Response to Comments

PROPOSED TEMPORARY OPEN STORAGE AND WAREHOUSE OF CONSTRUCTION MACHINERIES FOR A PERIOD OF THREE YEARS IN “AGRICULTURE” ZONE
 LOT 369 OF D.D. 87, HUNG LUNG HANG, NEW TERRITORIES

S.16 Planning Application No. A/NE-HLH/71

Figure 2 Drainage Plan

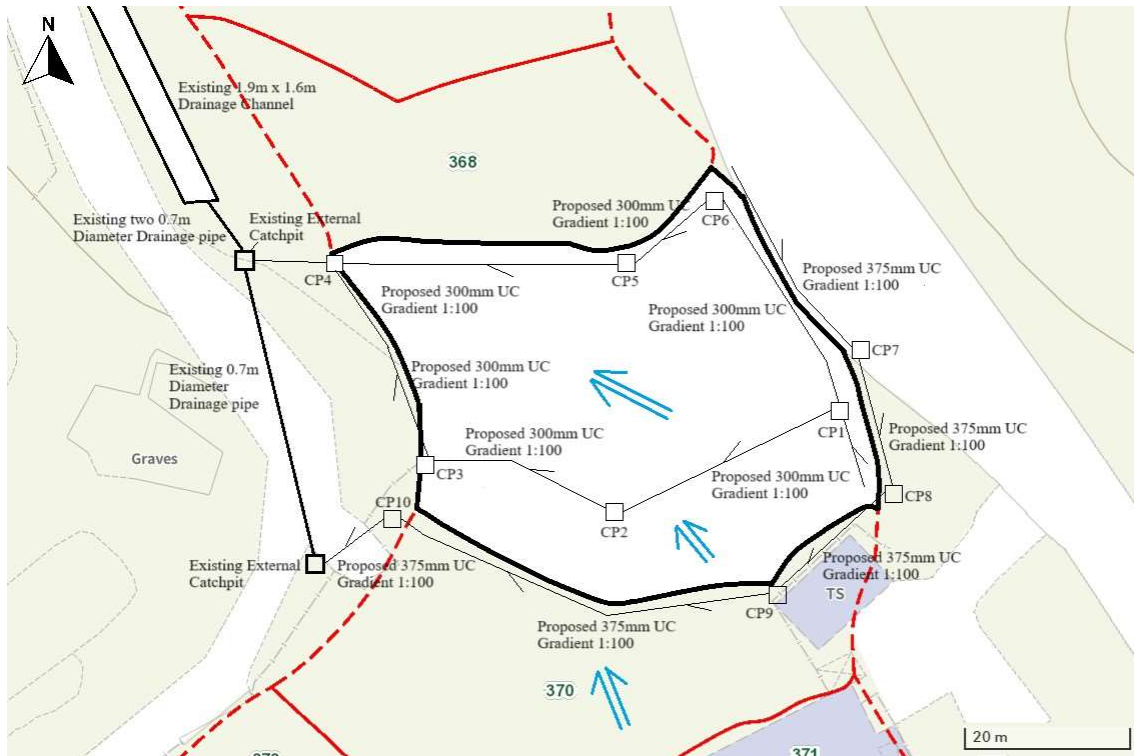
<p>d) Surface channel with grating covers should be provided along the site boundary.</p>	<p>Noted, surface channel with grating covers will be provided along the site boundary as shown in the revised drainage plan.</p>

Plan indicating the location of the camera and the angle of the photo:

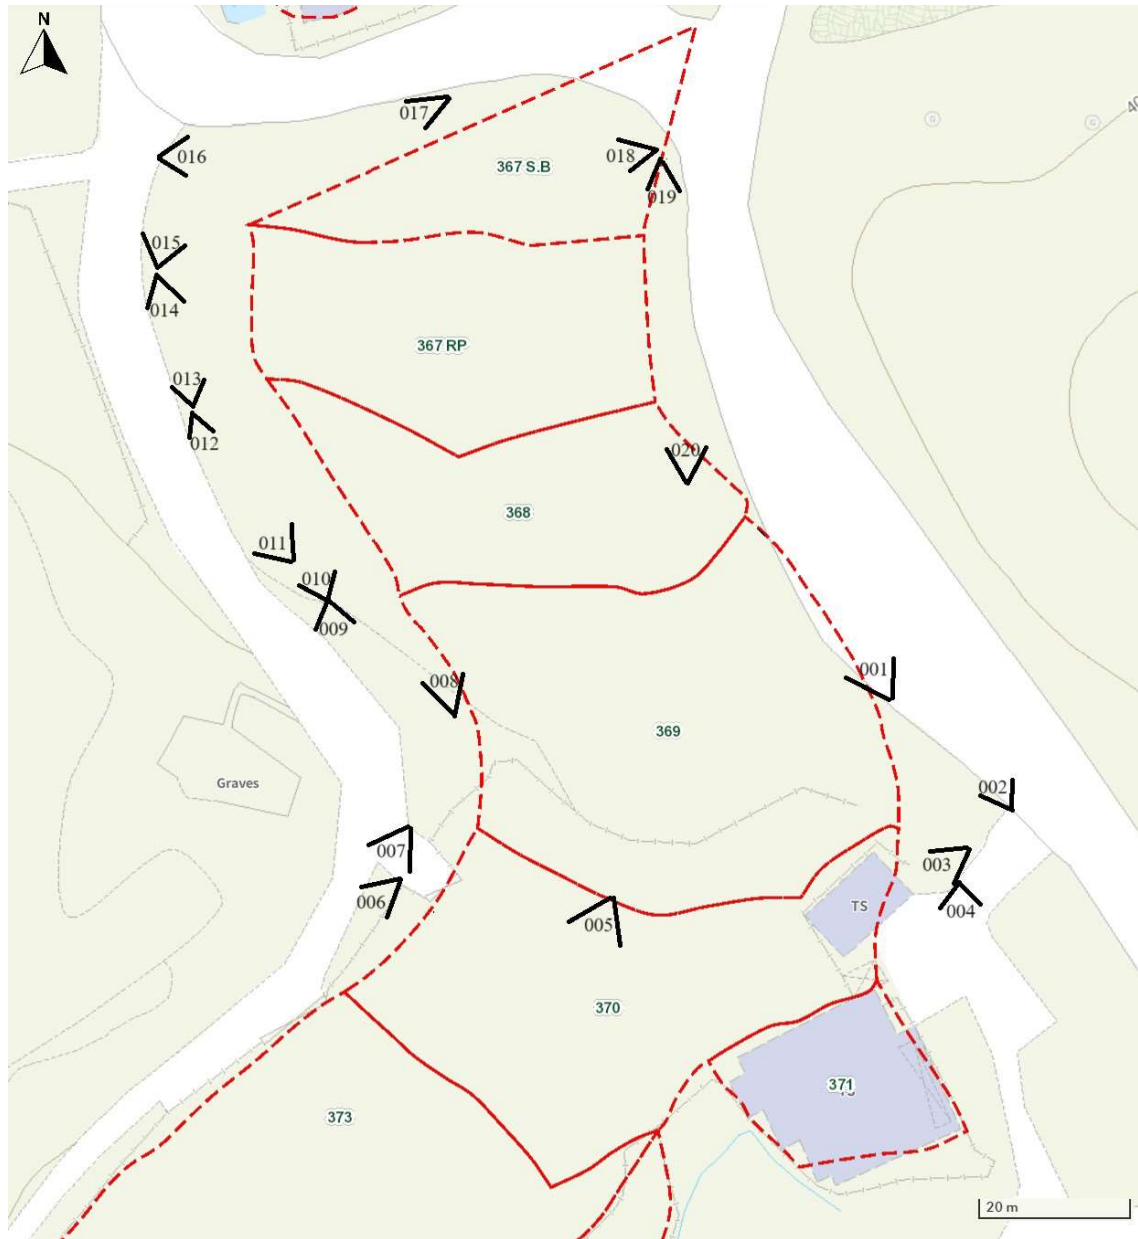
<p>b) Photos should be submitted clearly showing the current condition of the area around the site, the existing drainage/flowpaths around the site, the proposed drainage from the site to the downstream existing watercourse and the existing watercourse at about 20m intervals. The locations of the camera and the direction of each photo should also be indicated on a plan.</p>	<p>Attached in Appendix 1 are the photos and a plan of the location of the camera and the direction of the photos.</p>
<p>c) Section 1.3 of drainage proposal refers. With land to the south being at higher ground level, please review the potential overland flow to the site and the related external catchment area to be considered under the drainage design.</p>	<p>Please find revised drainage plan with proposed peripheral channels outside of the site boundaries to intercept and discharge runoff from the external catchments.</p>

**STANDARD CATCHPIT DETAILS
(SHEET 1 OF 5)**

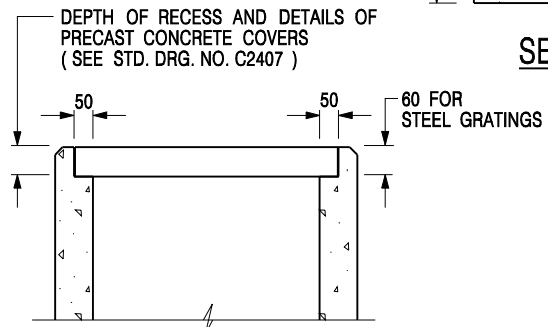
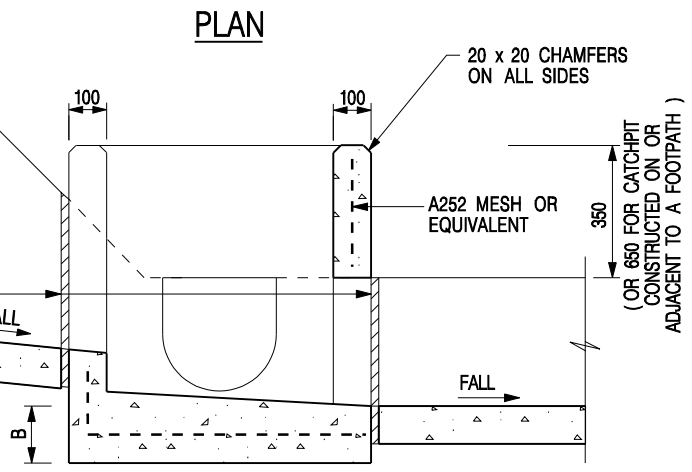
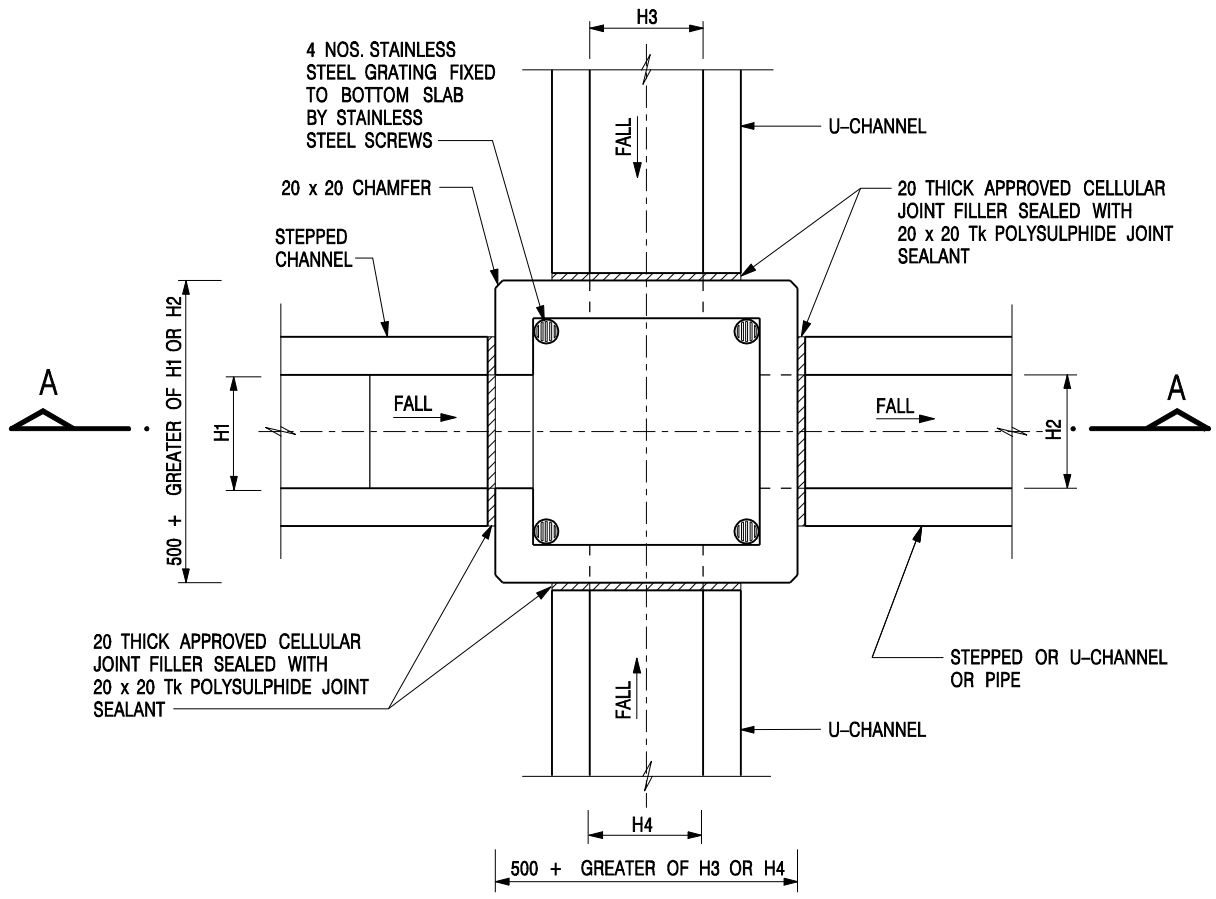
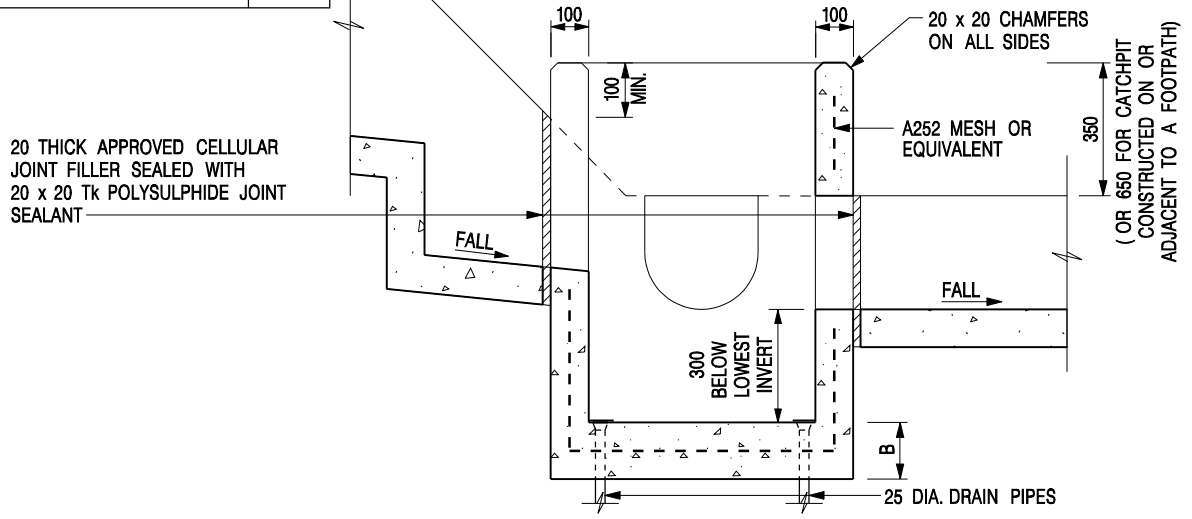
<p>e) The cover levels of proposed channels should be flush with the existing adjoining ground level.</p>	<p>Noted</p>
<p>f) A catchpit with covers should be provided where there is a change of direction of channel/drain. The details of the catchpit with covers shall be provided.</p>	<p>Noted, Locations of proposed catchpits are detailed on the drainage, and details of a standard catchpit with covers proposed are attached in Appendix II</p>
<p>g) Catchpits with sand trap shall be provided at the outlets of the proposed drainage system. The details of the catchpit with sand trap should be provided.</p>	<p>Noted. Details of the catchpit with sand trap are attached in Appendix II</p>
<p>h) The applicant should check and ensure that the existing drainage downstream to which the proposed connection will be made have adequate capacity and satisfactory condition to cater for the additional discharge from the captioned site. He should also ensure that the flow from this site will not overload the existing drainage system. Please provide further substantiation on the assumptions made on the checking of capacity of the natural stream.</p>	<p>The proposed drainage system will discharge into an existing external catchpit, which, using two 0.7m diameter pipes, discharges into a 1.9m wide x 1.6m deep drain before discharging into a 2.5m wide x 1.6m deep watercourse. The capacity of downstream drainage and watercourse is calculated in the attached drainage proposal, the capacity of the natural stream is calculated based on the watercourse is a canal with rough stony beds, weeds on earth beds in bad condition, with $n=0.04$. Conditions of the watercourse is shown in photos 016 and 017.</p>

Appendix III: Swept Path Analysis

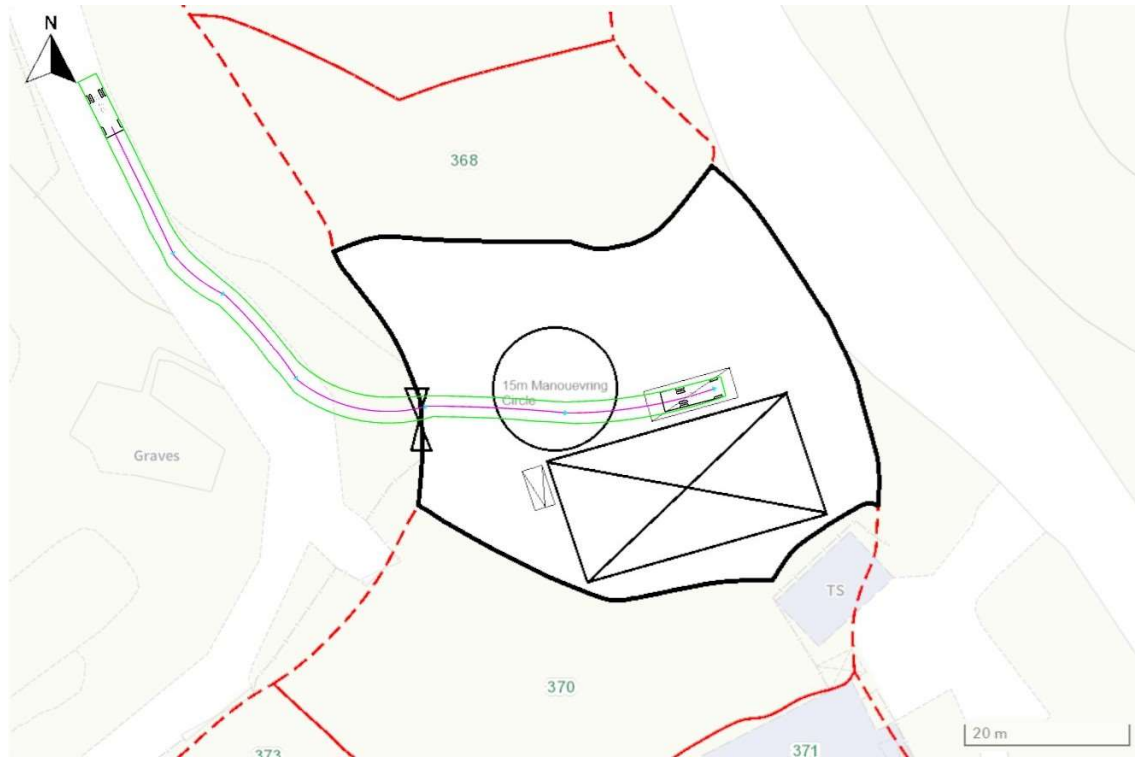
<p>l) The applicant should make good all the adjacent affected areas upon the completion of the drainage works.</p>	<p>Noted</p>
<p>m) The applicant shall allow all time free access for the Government and its agent to conduct site inspection on his completed drainage works</p>	<p>Noted</p>
<p>n) The applicant and the successive lot owners shall allow connections from the adjacent lots to the completed drainage works on Government Land when so required.</p>	<p>Noted</p>
<p>2. The site is in an area where no public sewerage connection is available. EPD should be consulted regarding the sewage treatment/disposal facilities for the proposed development.</p>	<p>Noted</p>
<p><u>Comments from Transport Department</u></p>	<p>The width of the vehicular access leading to the site is about 8.6m wide</p>
<p>i) The applicant should advise the width of the vehicular access leading to the site;</p>	<p></p>
<p>ii) The applicant shall demonstrate the satisfactory maneuvering of the goods vehicles entering and exiting the subject site, maneuvering within the subject site and into/out of the parking and loading/unloading spaces, preferably using the swept path analysis;</p>	<p>Please find attached in Appendix III swept path analysis.</p>
